# Reg 5 Comment Appendices

C&H Hog Farms  
Newton County, Arkansas

FIGURE 1 EXAMPLE OF A FIELD 21A, WHICH IS CONTORTED AND INAPPROPRIATE FOR WASTE APPLICATION

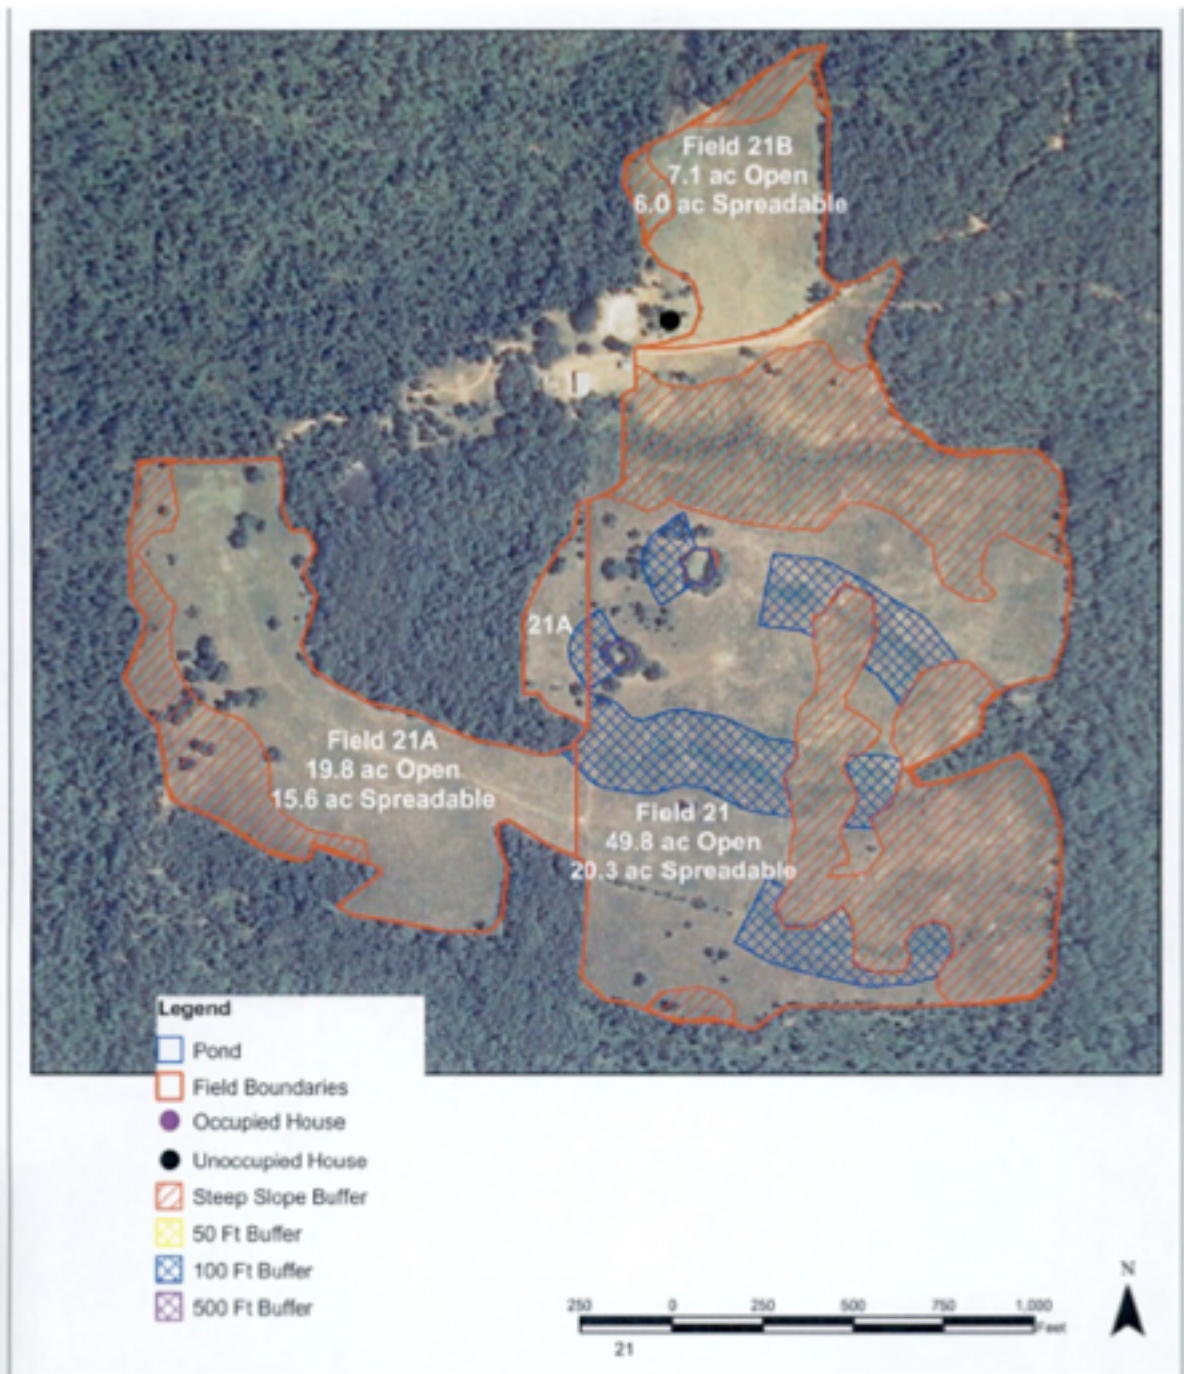
## Appendix B10 Unrealistic Buffer Zones Page 1 of 1

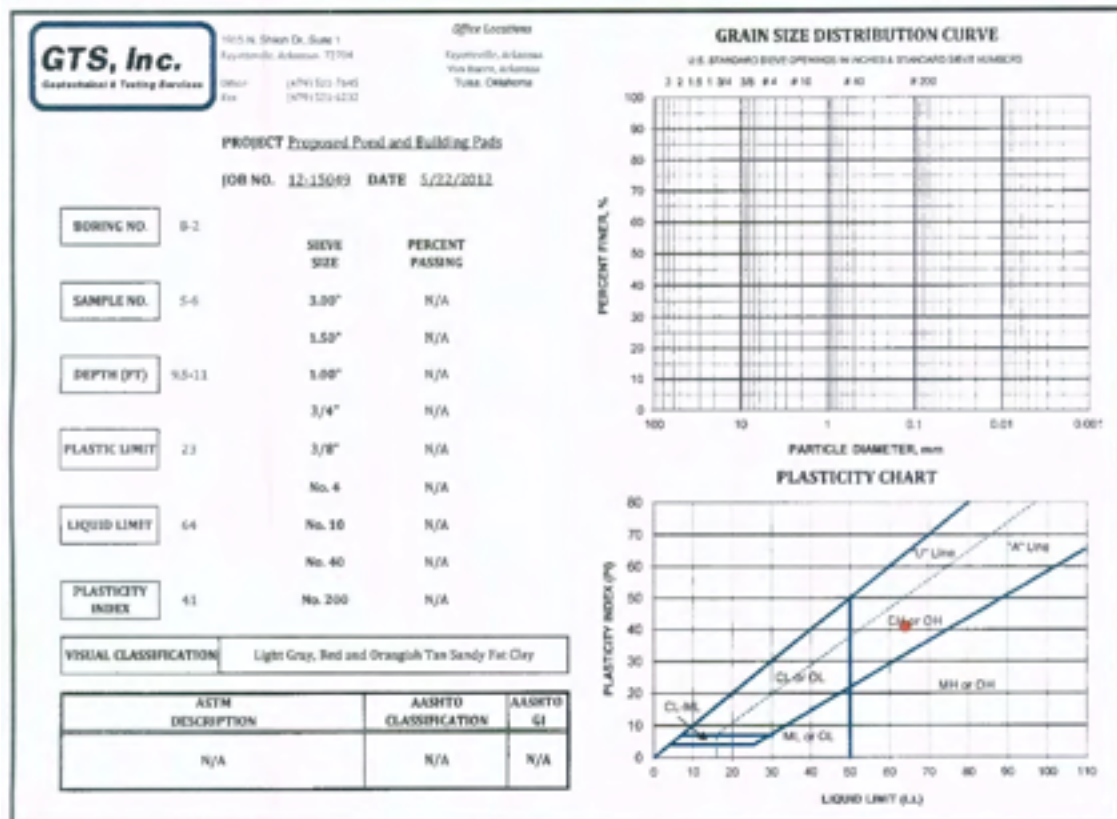
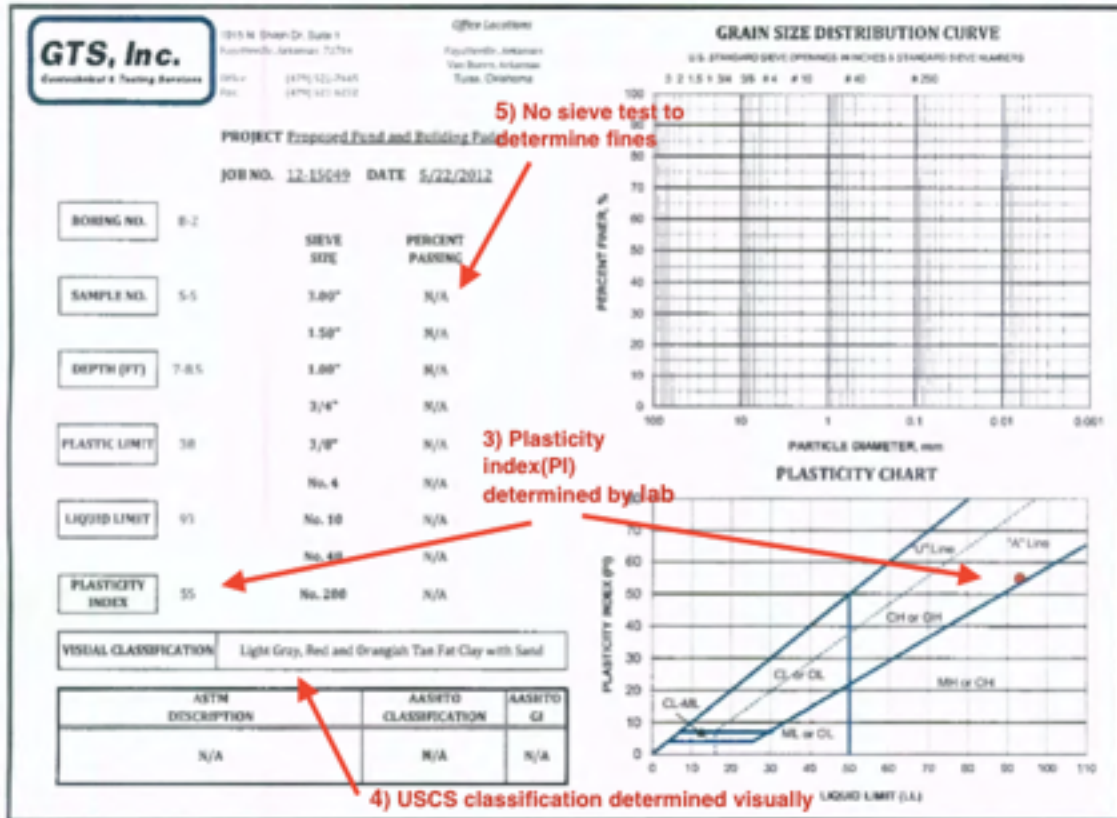
2) Samples 5 & 6 from Boring No B-2. B-3 samples 5 and 6 are also used but not shown here. USCS designations are not determined yet.

### HYDRAULIC CONDUCTIVITY TEST RESULTS

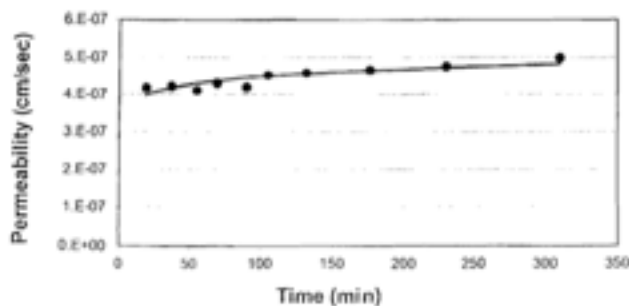
## Appendix C3 - Review of permeability determination

Appendix C10B - Improperly Abandoned well

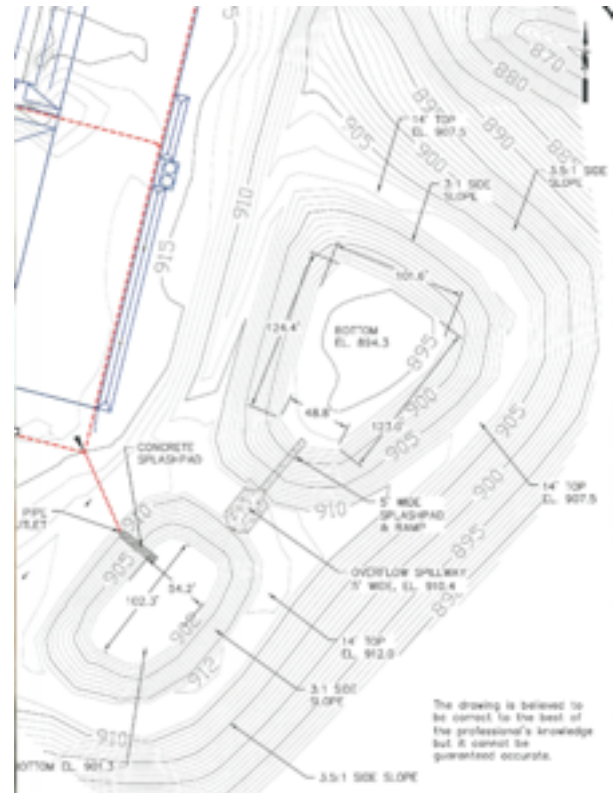
# Appendix C10B - Improperly Abandoned well

**Figure 7-8** Perched aquifer

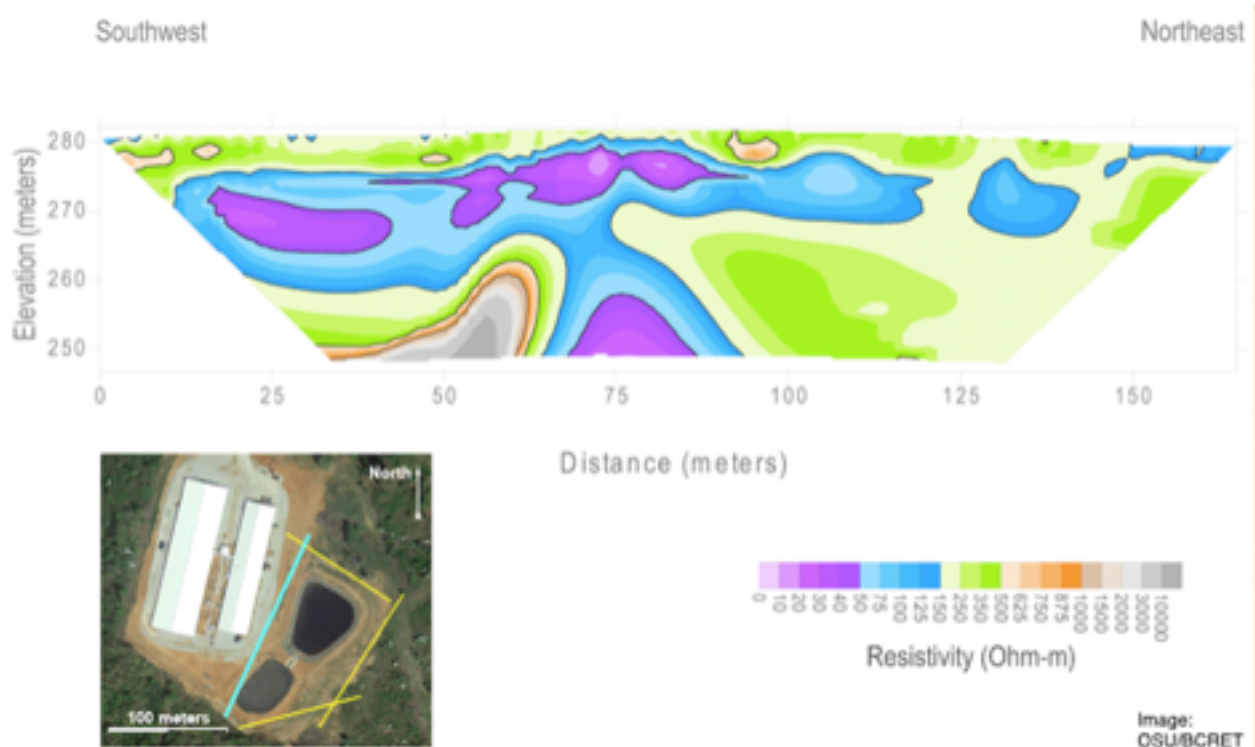
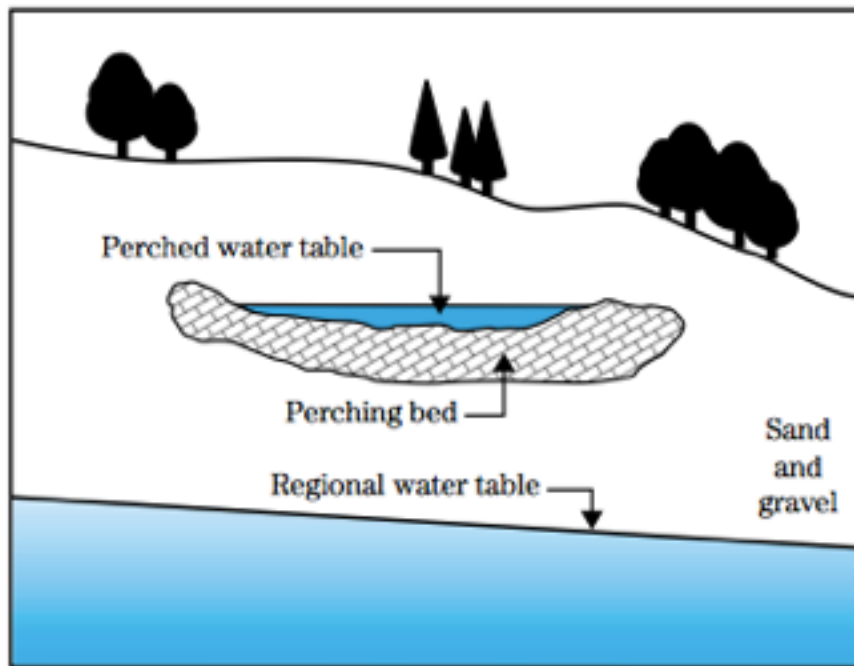
## Appendix C13 Evidence of perched groundwater.
